Re: Approval of a Preliminary Plat of a Major Subdivision known as Stoney Creek North Third Addition located on Parcels #850623008 & #850639002, totaling 16.42 acres, more or less, legally described as part of the SE $\frac{1}{4}$ NE $\frac{1}{4}$ of Section 6 AND part of the NE $\frac{1}{4}$ SE $\frac{1}{4}$ of Section 6 in Pleasant Valley Township

PLANNING & ZONING COMMISSION
STAFF REPORT
May 3, 2019

Request: Preliminary Plat of Stoney Creek West Addition Subdivision, a 14 lot residential subdivision.

PRELIMINARY PLAT OF
STONEY CREEK WEST ADDITION
TO SCOTT COUNTY, IOWA

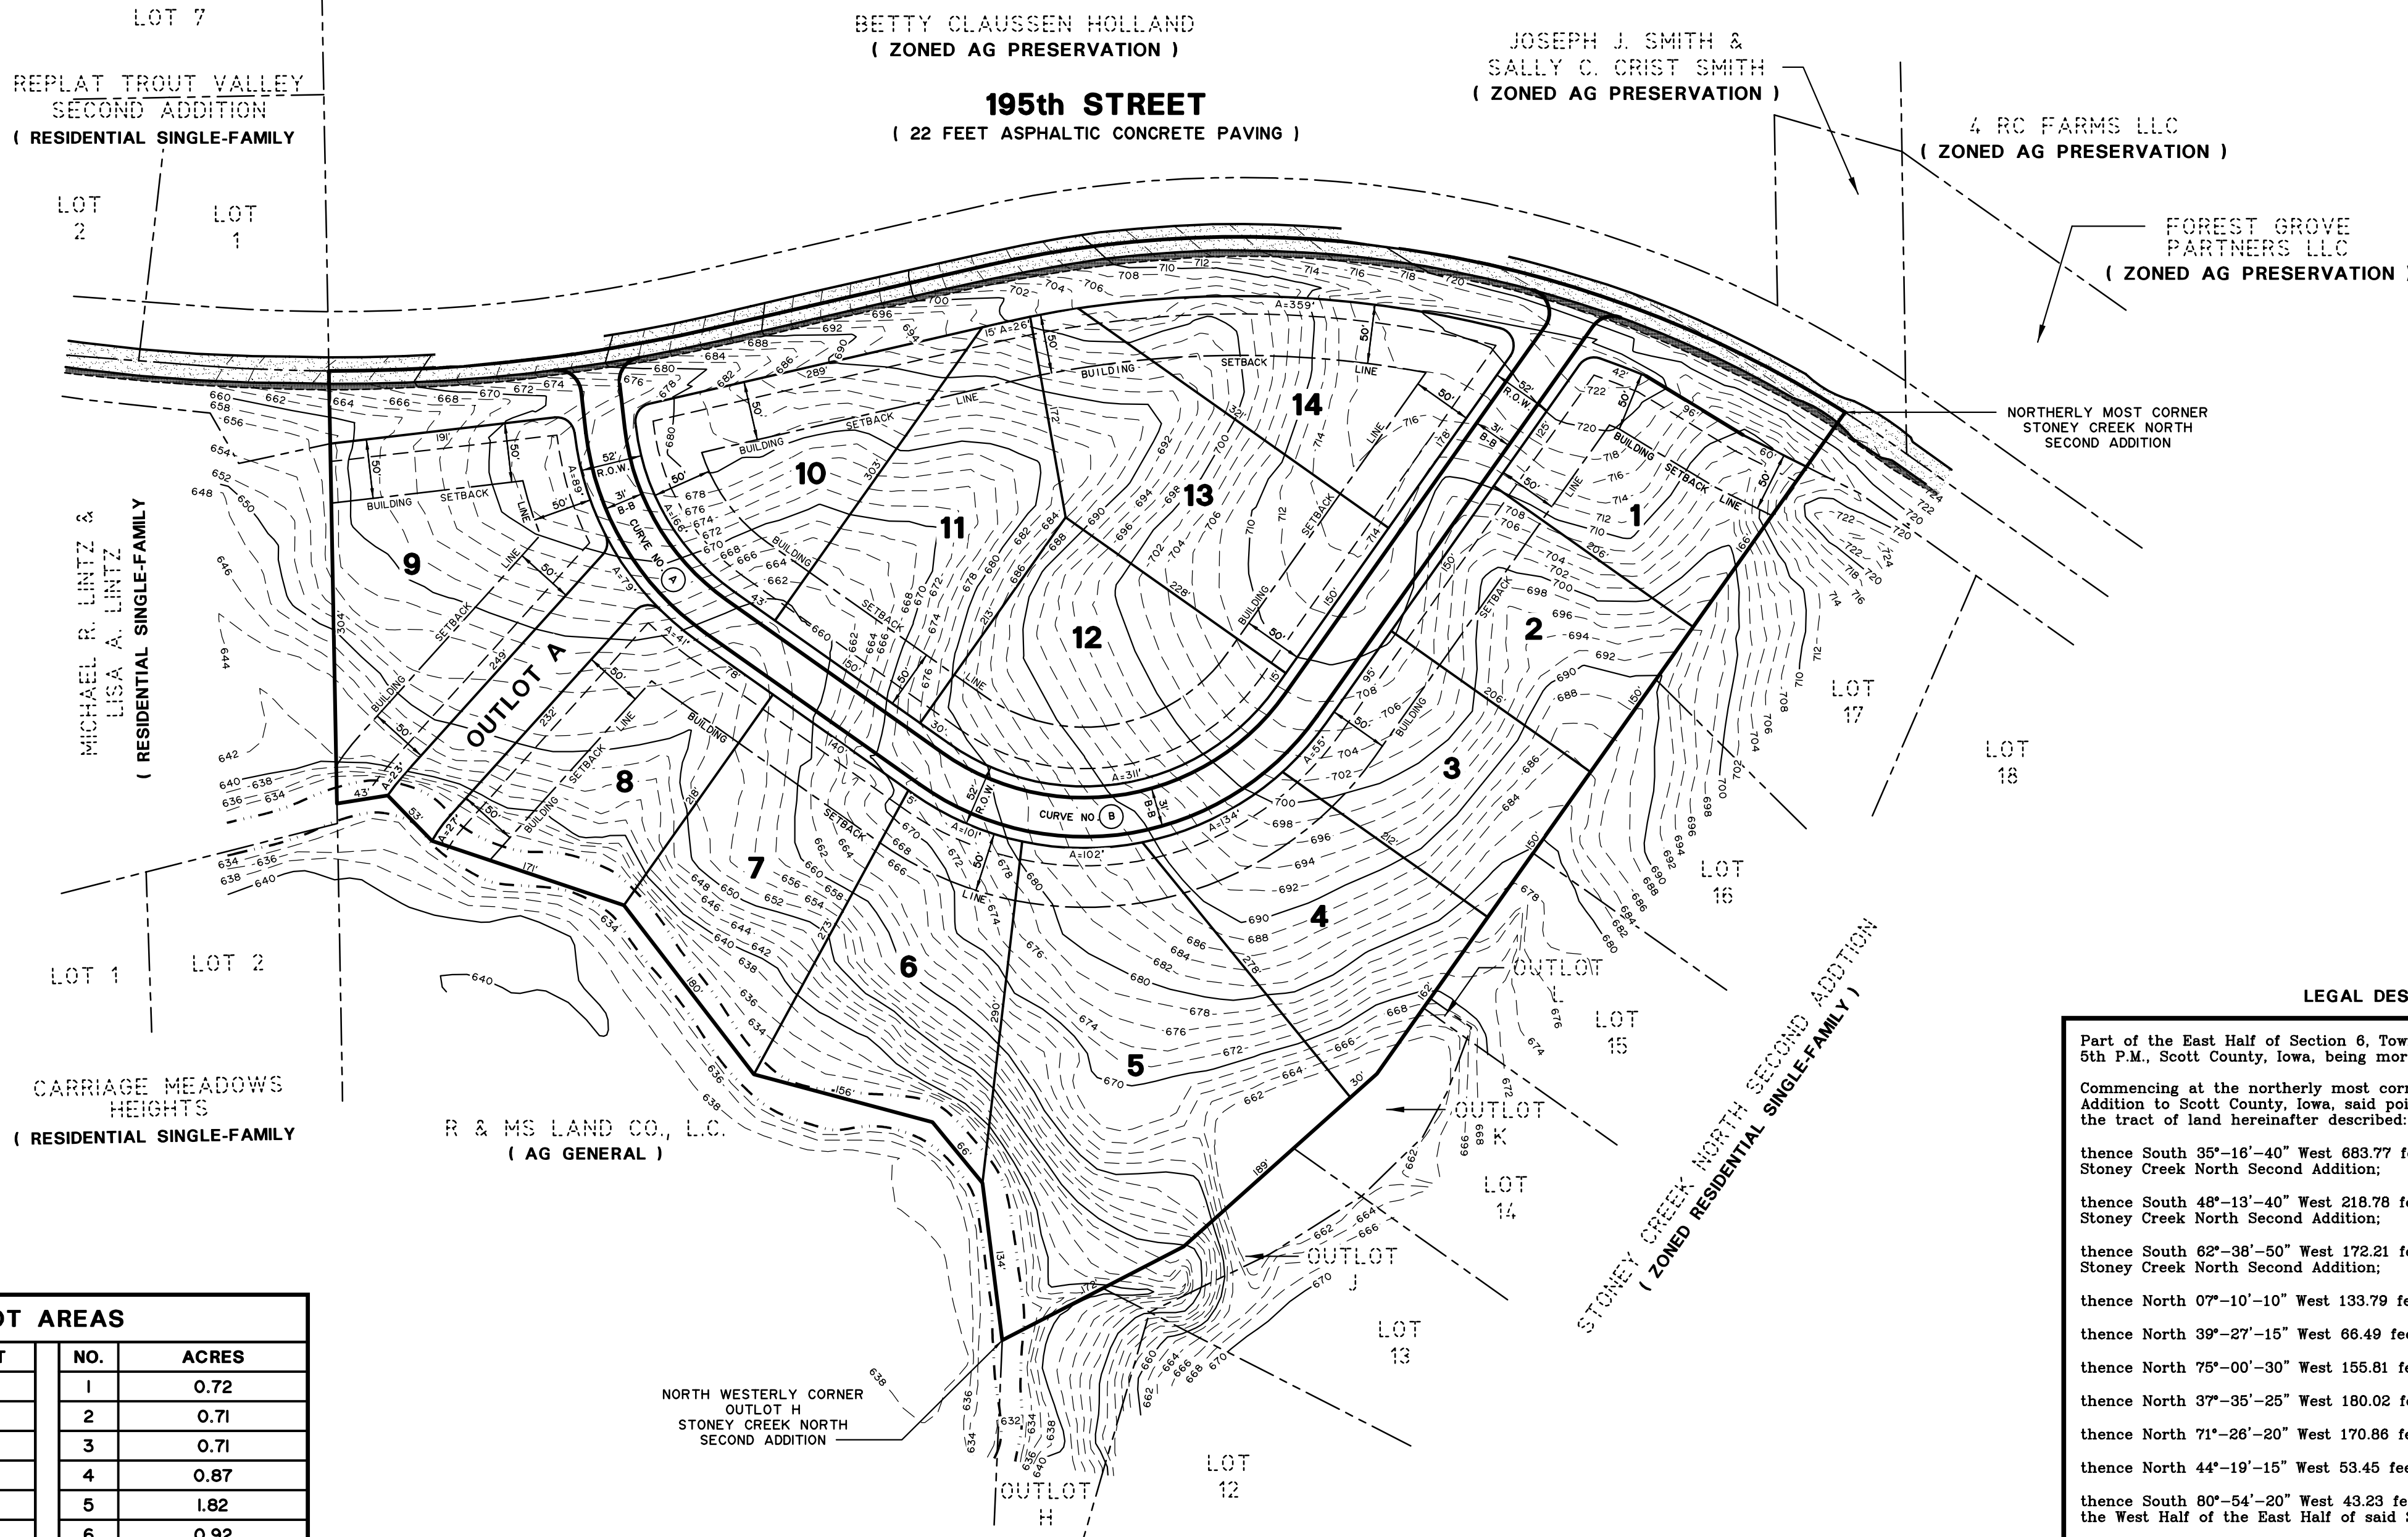
GENERAL COMMENTS: This request is for approval of a Preliminary Plat for a 14 lot residential subdivision on a 39 acre parcel zoned Single-Family Residential (R-1). The property has frontage and access to Forest Grove Road. The Preliminary Plat shows a loop street with two entrances to Forest Grove Road. The proposed street configuration has five (5) lots inside the loop and the remaining nine (9) lots on the exterior of the loop. Approximately half of the lots shown are one acre in size and the remainder are slightly larger, with the largest 2.5 to 3 acres in size. The property is adjacent to Stoney Creek North II to the east, Carriage Meadows Heights to the west, and Spencer Creek Estates to the south. The original Stoney Creek Subdivision, with 29 residential lots, is located south and east of this property.

The Preliminary Plat does show one 0.33 acre outlot which is a fifty (50') feet wide strip of land for future road extension to provide access to the portion of the property on the other side of Spencer Creek that would only be accessible by a bridge over the creek..

STAFF REVIEW: Staff has reviewed this request for compliance with the requirements of the Subdivision Regulations and the Zoning Ordinance. All of the proposed lots exceed the minimum lot size required by Health Department Regulations and the R-1 zoning district requirements. The plat does not make any provision for access through this property to the adjacent undeveloped land to the west. However the proposed 14 lots do not exceed the maximum number of thirty (30) lots that can be served by a single access.

Both Stoney Creek North and Stoney Creek North II had loop streets with a single intersection to Forest Grove Road. As stated above, the current configuration would have two intersections with Forest Grove Road. All lots will only have access to the interior loop road. The lots that are also adjacent to Forest Grove Road will not be permitted to have direct access on to this County Road.

The County Engineer is not recommending that these subdivision roads be accepted onto the County Secondary Road system. Road maintenance will therefore have to be provided by a homeowners association.

Subdivisions containing less than forty (40) lots may install individual on-site systems that meet County Health Department regulations. The applicant is proposing that each lot will be served by a private on-site sand filter wastewater treatment system unless a septic system is approved by the County Health Department. The Health Department has not, as of yet, submitted any comments on this proposed Preliminary Plat. The Health Department had expressed concern with individual systems during the review of the previous two Stoney Creek Subdivisions. Those concerns related to the steep slopes and poor soil conditions on the property.

The Subdivision regulations require all internal street to be adequately drained and that detention facilities adequate to capture the runoff from a one hundred (100) year rain event at post-developed flows shall be place in the subdivision. The release rate from that detention area shall not exceed the volume produced by a five (5) year event calculated at pre-developed flows. The stormwater drainage plan and the design of detention facilities are normally completed after Preliminary Plat approval and reviewed and approved prior to Final Plat approval.

The applicant proposes to serve the lots with water from the Iowa American water system which is currently located along Forest Grove Road. This will also allow the subdivision to be served with fire hydrants.

Spencer Creek runs along the south boundary of this property. The limits of the designated 100-year floodplain will need to be shown on the Final Plat. A condition of the previous approval of other plats in this area has been the dedication of a sewer main easement along Spencer Creek to provide for the future extension of central sewer system to serve this area. Staff would recommend that such an easement be retained as a condition of this plat approval.

The subdivision regulations require the submission of an erosion and sediment control plan prior to Preliminary Plat approval. No plan has, as of yet, been submitted but would be required in conjunction with the road construction plans. Those plans shall include information regarding the soil types, the specifications for temporary and permanent erosion and sedimentation control and the proposed timing schedule and development sequence.

All residential subdivisions with fifteen lots or greater must provide a minimum area of 10,000 square feet of open space plus 2,000 square feet for every lot over fifteen. With fourteen (14) lots this subdivision is not required to meet the open space requirement. This Preliminary Plat does not show any common open space and is not required to with only 14 lots. However since it includes an area on the south side of the creek that eventually may be developed, Staff recommends that the applicant construct a bike and pedestrian path within a 15 foot wide easement along the north boundary of the subdivision, adjacent to the County road easement extending along the north boundary of the three Stoney Creek subdivisions. This would allow pedestrian access between the three subdivisions without residents having to go out onto the County road. The developer previously has constructed a pedestrian bridge over Spencer Creek for access between the two subdivisions, Stoney Creek and Stoney Creek North.

RECOMMENDATION: Staff recommends that the Preliminary Plat for Stoney Creek West Subdivision be approved with the following conditions:

1. An improved pedestrian bike path along the northern boundary of the subdivision adjacent to the County Road easement be provided;
2. An erosion and sediment control plan be in accordance with the requirements of the Natural Resources Conservation Service and the County Engineer be submitted in conjunction with the road construction plans;
3. The proposed wastewater treatment facilities meet Health Department requirements;
4. Iowa American Water system service be extended to serve this subdivision;
5. The City of Bettendorf review and approve the Preliminary and Final Plat;
6. The County Engineer review and approve all street construction plans prior to construction
7. The covenants include provision for private road maintenance ; and
8. The subdivision infrastructure improvements be completed or a surety bond posted prior to Final Plat approval.
